HARTFIELD PLACE, SWORDS ROAD, WHITEHALL RESIDENTIAL DEVELOPMENT - AMENDMENT CAR AND CYCLE STRATEGY REPORT 02

POST LRD STAGE 01

Car & Cycle Strategy Report: Version 02

This report also addresses queries raised by DCC traffic and transport department following submission of Version 01 of this report.

Current LRD Application: Block D & E - Proposed Lower Ground / Semi-Basement Floor Plan

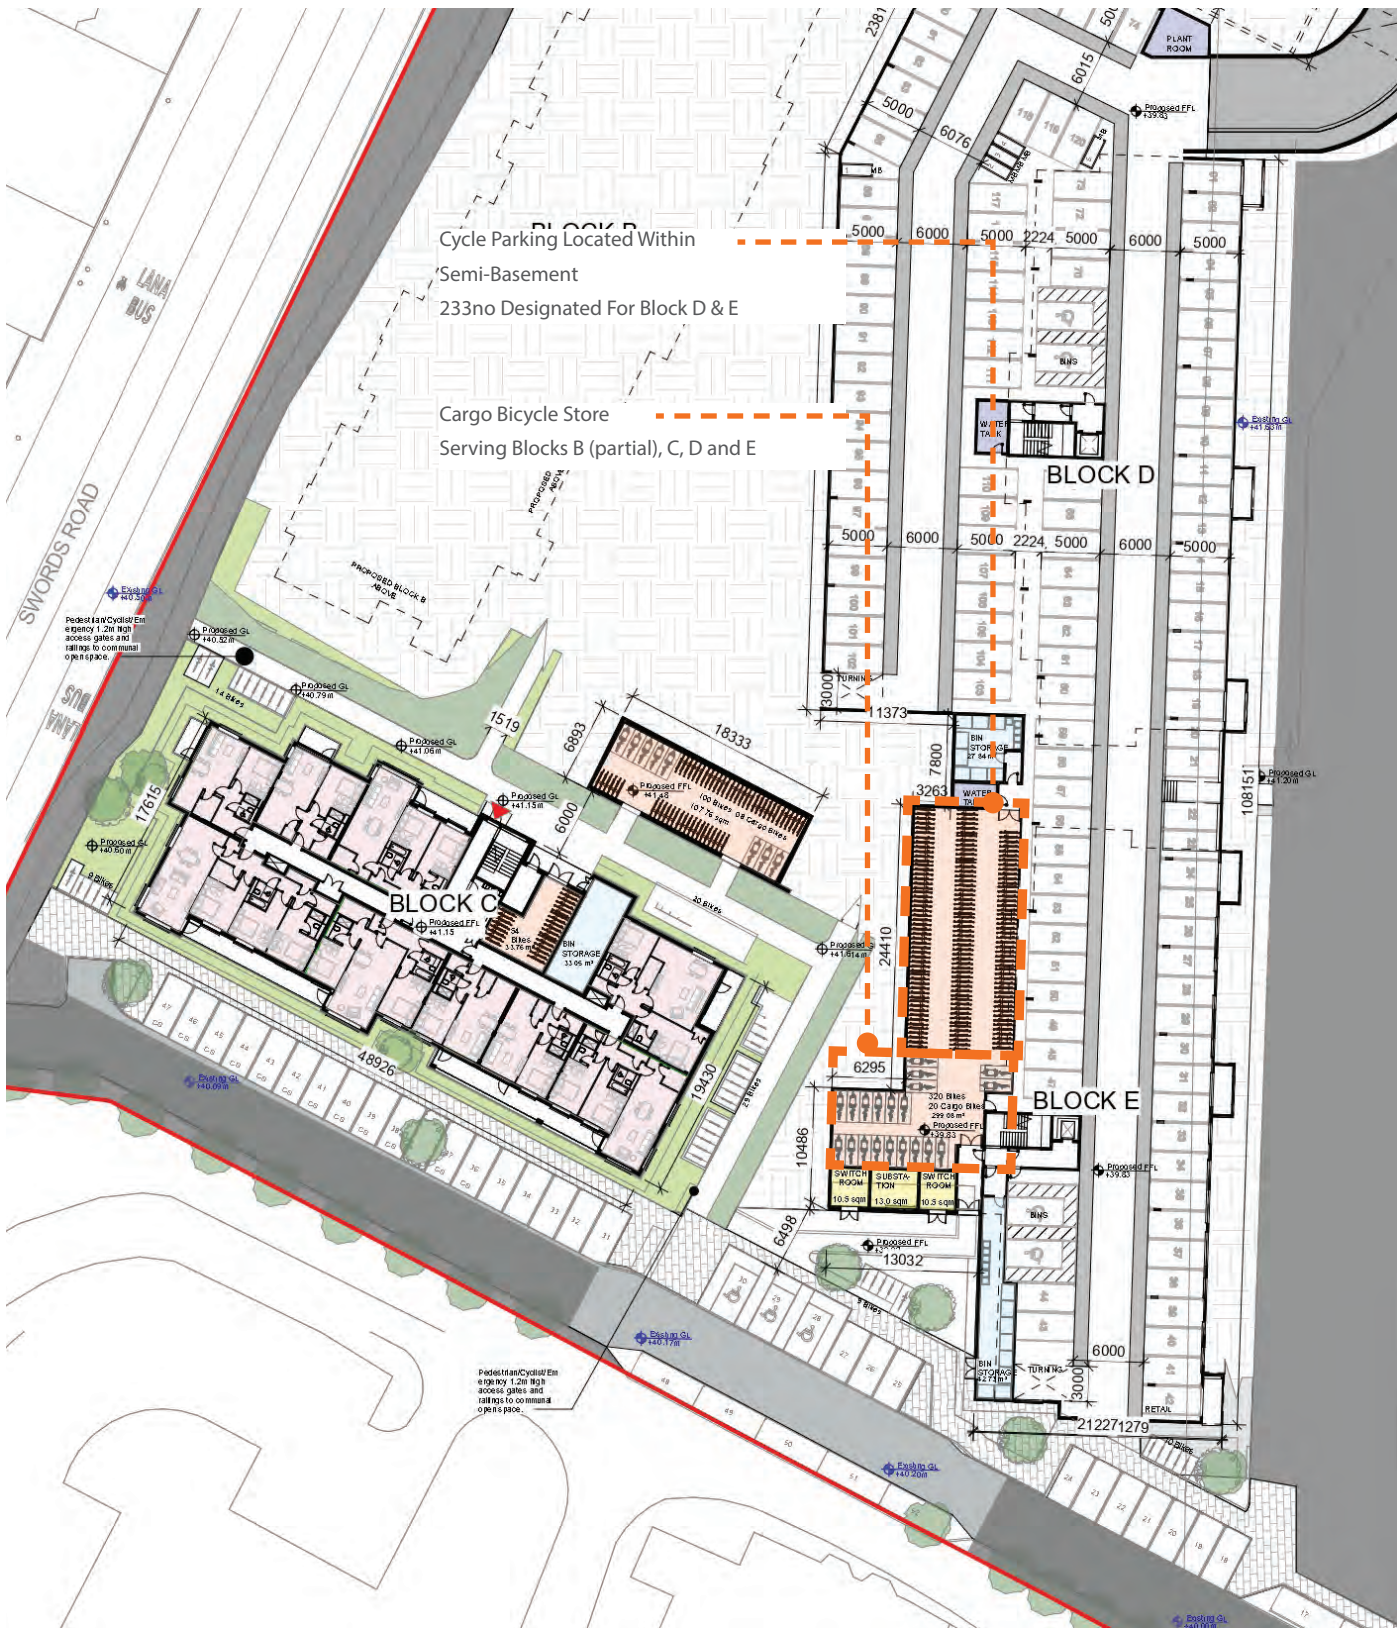
CWOB have prepared separate scaled drawings for each of the two primary bicycle stores, the first located within the southern end of the communal amenity space and the second located within the semi-basement of Blocks D and E. There is a small bicycle store located within ground floor level of Blocks A, B and C which will be shown on the ground floor GA plans for these buildings.
- vii. Concern with the length of journey, and number of doors from the public road to spaces within the semi-basement for Block D and Block E.**

The layout of the bicycle store within the semi-basement of Block D and E has been revised and the number of doors reduced to two number double fire doors for ease of use.
- viii. Not clear whether cycling is permitted within the semi-basement.**

The layout of the bicycle store within the semi-basement of Block D and E has been revised so cyclist have no longer any need to pass through the car parking zone.
- ix. Clarify the gradients from the public road to the bicycle parking. Should be no greater than 5%.**

1. Bicycle maintenance station

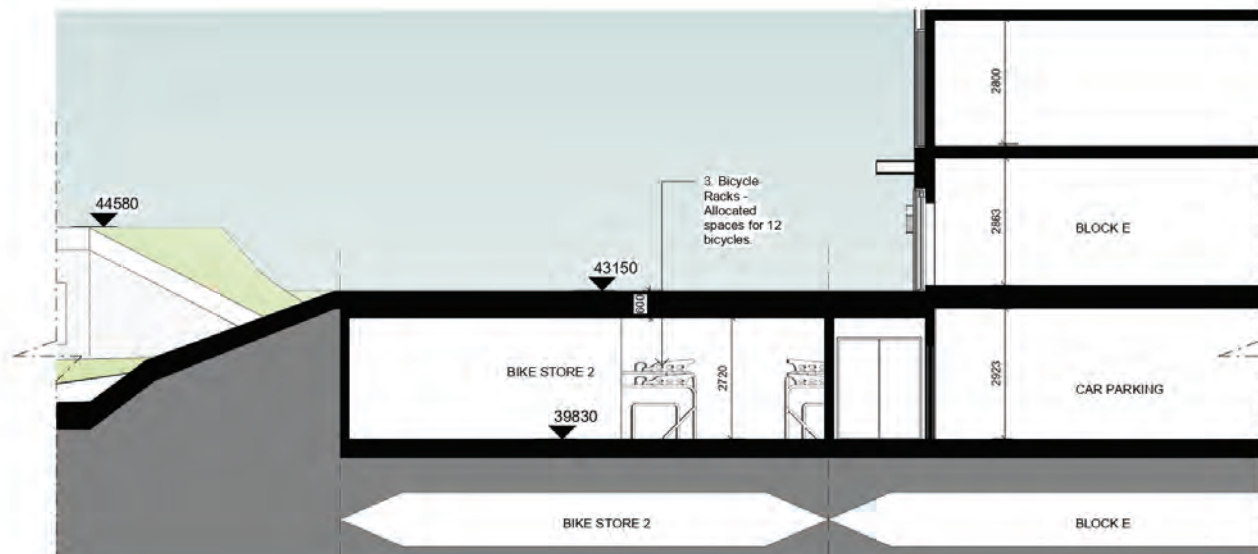
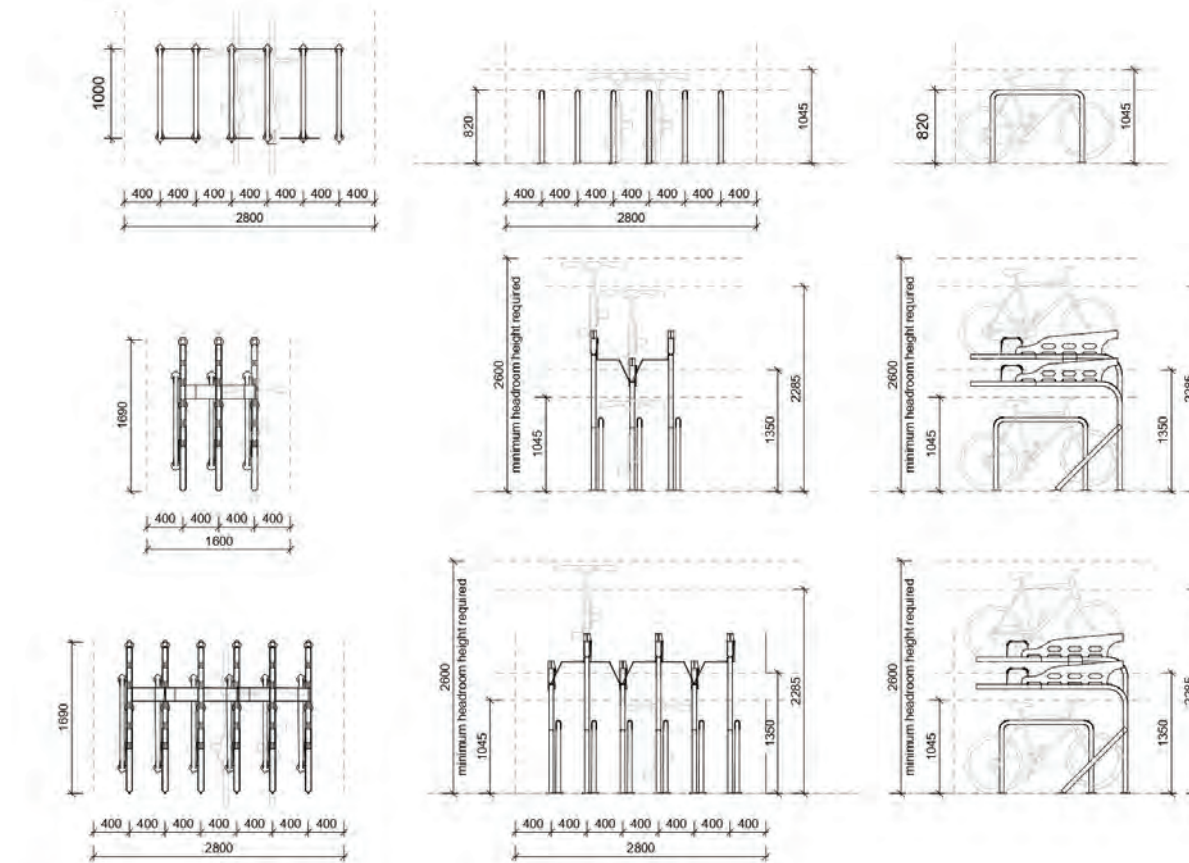
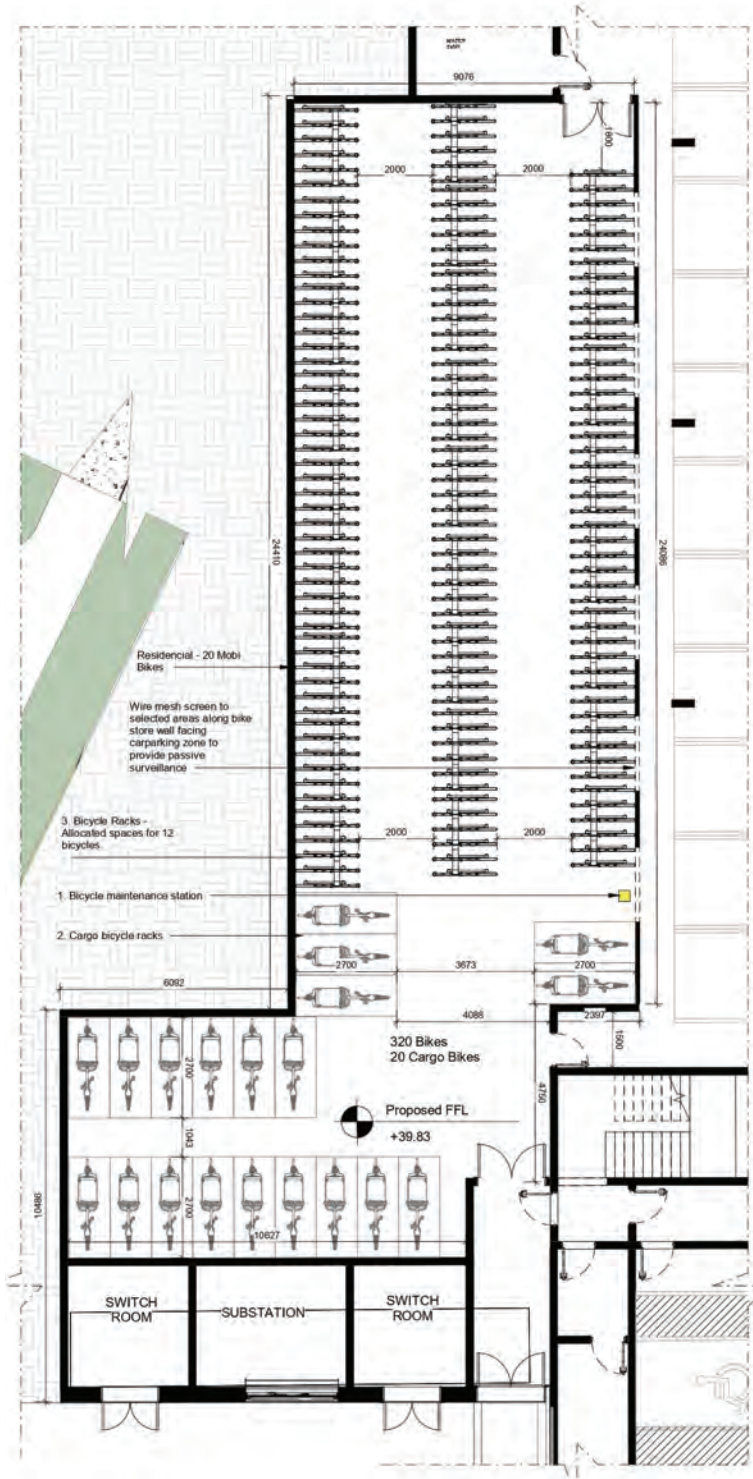
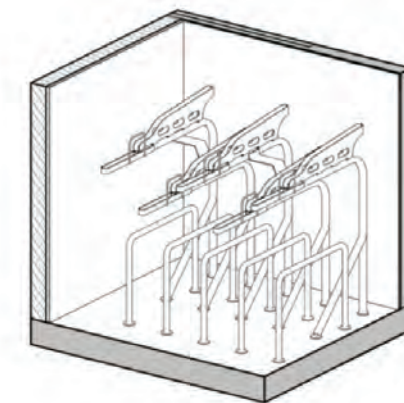
i. To provide complementary bicycle parking infrastructure, for example: a bicycle maintenance / repair area etc.

We have included a bicycle maintenance/repair facility within the largest cycle store located within the semi basement of Blocks D/E.
